DEVELOPMENT REVIEW BOARD REPORT

CASE NUMBER/
PROJECT NAME

38-DR-2005
Arizona School of Real Estate Colors/Parking Lot

REQUEST

ELEVATIONS

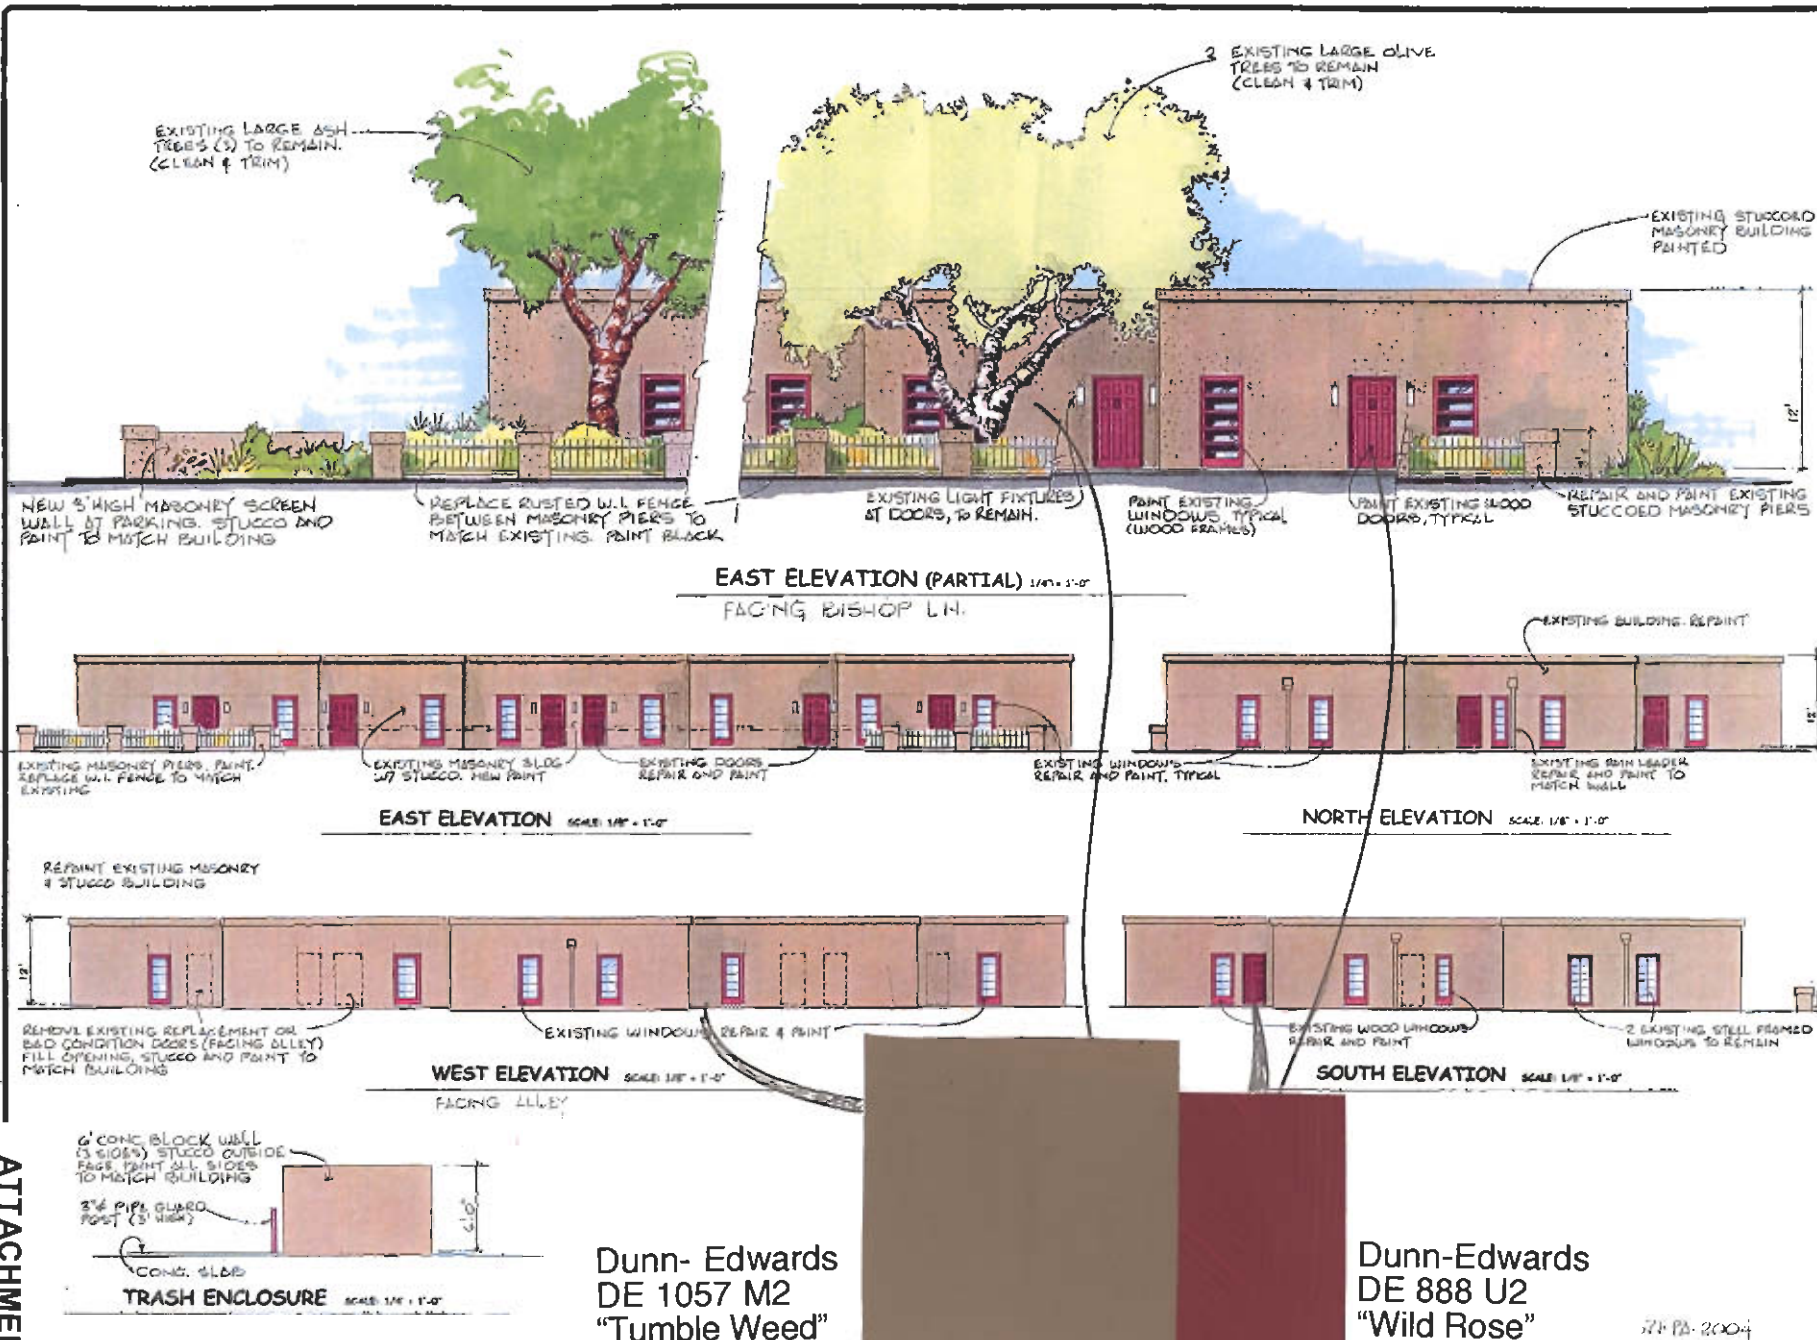
5. Dooley wall fencing shall not be allowed.
6. All walls shall match the architectural color, materials and finish of the building(s).
7. *All colors that are shown as tan on the elevation drawing shall be Dunn – Edwards DE 1057 M2 “Tumble Weed” W704 Acrylic-flat or equivalent.*

8. *All colors that are shown as maroon on the elevation drawings shall be Dunn – Edwards DE 888 U2 “Wild Rose” W940 Permaplast or equivalent.*
